PANEL RECOMMENDATIONS AND OFFICER RECOMMENDED POSITION FOR ADOPTION

PART I - PRECINCT-WIDE RECOMMENDATIONS

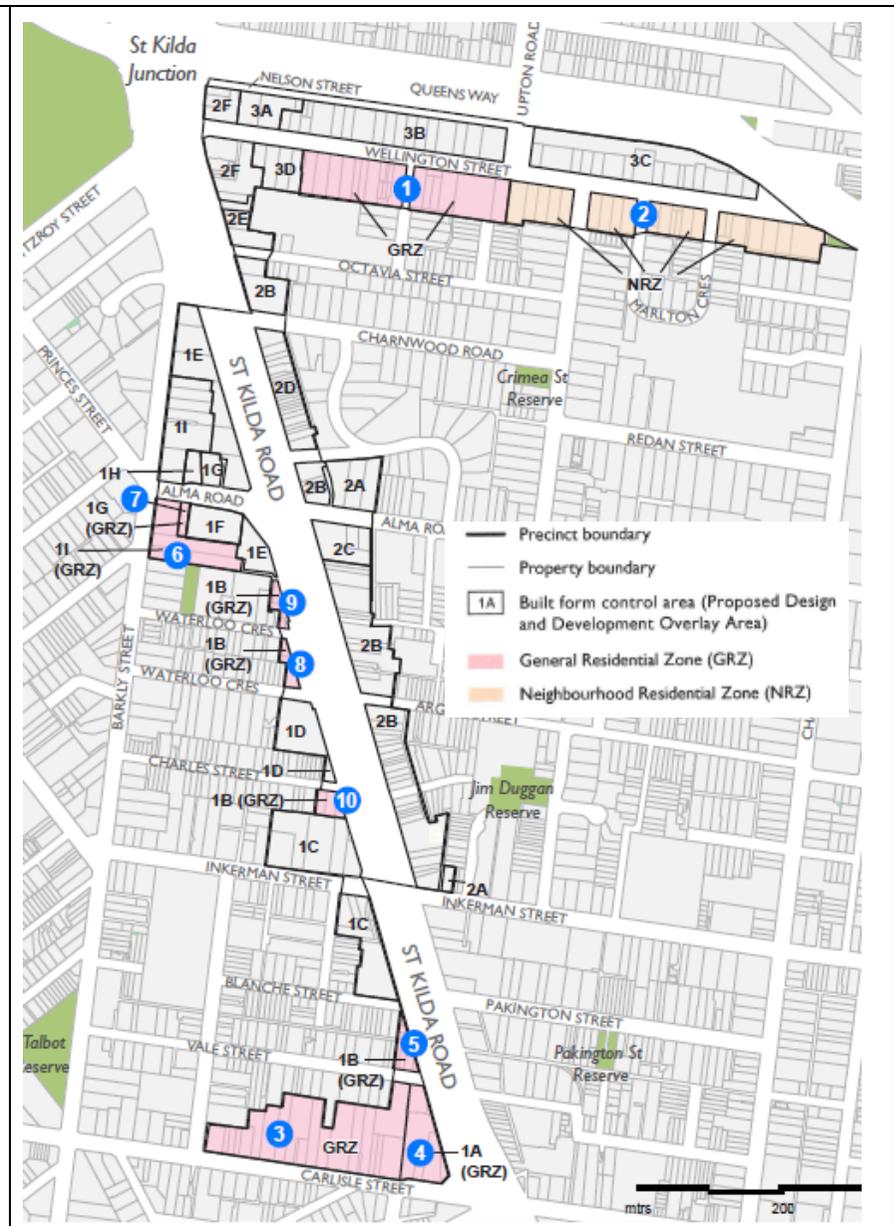
Issue	Panel Rec #	Panel recommended changes	Officer recommended changes																																												
		<p><i>Application of the DDO to residential land in the Precinct</i></p> <ul style="list-style-type: none"> The Panel suggests that a higher mandatory height (increased by one or two storeys) should be specified in the schedule to the GRZ however, a lower preferred height could also be included in the zone character statement and decision guidelines or an extended DDO27. Developments could qualify for an additional storey or two, subject to demonstrating the Framework and other planning objectives are satisfied. In light of the new mandatory garden area requirement and height controls in the new residential zone provisions, it was submitted that consideration should be given to an alternative MUZ. It was recognised that this could be deemed a substantive change that would warrant notice to those who may be affected. 	<ul style="list-style-type: none"> The Panel also suggested that Council give consideration as to whether residential zoned land in the Precinct should be rezoned to the Residential Growth Zone (where mandatory height controls do not apply). This is not supported at this stage, however could be addressed as part of development of a new Housing Strategy (See also Recommendation 29.) Having regard to this issue, the following is recommended:

<table><tr> <th data-bbox="1167 464 1245 667">Map ref. # See Map</th> <th data-bbox="1245 464 1529 667">Location / Area</th> <th data-bbox="1529 464 1834 667">Height exhibited in C122</th> <th data-bbox="1834 464 2020 667">Recommended heights to be included in a Schedule to the GRZ (to allow higher heights than the default of 3 storeys)</th> </tr><tr> <td data-bbox="1167 667 1245 740">①</td> <td data-bbox="1245 667 1529 740">Southern side of Wellington Street – GRZ</td> <td data-bbox="1529 667 1834 740">3 storeys mandatory (Height included in Schedule to the zone)</td> <td data-bbox="1834 667 2020 740">No specific schedule required</td> </tr><tr> <td data-bbox="1167 740 1245 813">②</td> <td data-bbox="1245 740 1529 813">Southern side of Wellington Street – NRZ</td> <td data-bbox="1529 740 1834 813">2 storeys mandatory (Height included in Schedule to the zone)</td> <td data-bbox="1834 740 2020 813">No specific schedule required</td> </tr><tr> <td data-bbox="1167 813 1245 874">③</td> <td data-bbox="1245 813 1529 874">Carlisle Street – GRZ</td> <td data-bbox="1529 813 1834 874">4 storeys discretionary (Height included in Policy)</td> <td data-bbox="1834 813 2020 874">5 storeys mandatory</td> </tr><tr> <td data-bbox="1167 874 1245 948">④</td> <td data-bbox="1245 874 1529 948">Corner of Carlisle Street and St Kilda Road – Area 1A (GRZ)</td> <td data-bbox="1529 874 1834 948">5 storeys discretionary (Height included in DDO)</td> <td data-bbox="1834 874 2020 948">6 storeys mandatory</td> </tr><tr> <td data-bbox="1167 948 1245 1008">⑤</td> <td data-bbox="1245 948 1529 1008">189-193 St Kilda Road – Area 1B (GRZ)</td> <td data-bbox="1529 948 1834 1008">4 storeys discretionary (Height included in DDO)</td> <td data-bbox="1834 948 2020 1008">5 storeys mandatory</td> </tr><tr> <td data-bbox="1167 1008 1245 1067">⑥</td> <td data-bbox="1245 1008 1529 1067">Barkly Street – Area 11 (GRZ)</td> <td data-bbox="1529 1008 1834 1067">4 storeys mandatory (Height included in DDO)</td> <td data-bbox="1834 1008 2020 1067">4 storeys mandatory</td> </tr><tr> <td data-bbox="1167 1067 1245 1128">⑦</td> <td data-bbox="1245 1067 1529 1128">Alma Road – Area 1G (GRZ)</td> <td data-bbox="1529 1067 1834 1128">6 storeys mandatory (Height included in DDO)</td> <td data-bbox="1834 1067 2020 1128">6 storeys mandatory</td> </tr><tr> <td data-bbox="1167 1128 1245 1187">⑧</td> <td data-bbox="1245 1128 1529 1187">Waterloo Crescent* (GRZ)</td> <td data-bbox="1529 1128 1834 1187">4 storeys discretionary (Height included in DDO)</td> <td data-bbox="1834 1128 2020 1187">No specific schedule required</td> </tr><tr> <td data-bbox="1167 1187 1245 1248">⑨</td> <td data-bbox="1245 1187 1529 1248">189-193 St Kilda Road* (GRZ)</td> <td data-bbox="1529 1187 1834 1248">4 storeys discretionary (Height included in DDO)</td> <td data-bbox="1834 1187 2020 1248">4 storeys mandatory</td> </tr><tr> <td data-bbox="1167 1248 1245 1294">⑩</td> <td data-bbox="1245 1248 1529 1294">Charles Street (GRZ)</td> <td data-bbox="1529 1248 1834 1294">4 storeys discretionary (Height included in DDO)</td> <td data-bbox="1834 1248 2020 1294">4 storey mandatory</td> </tr></table>
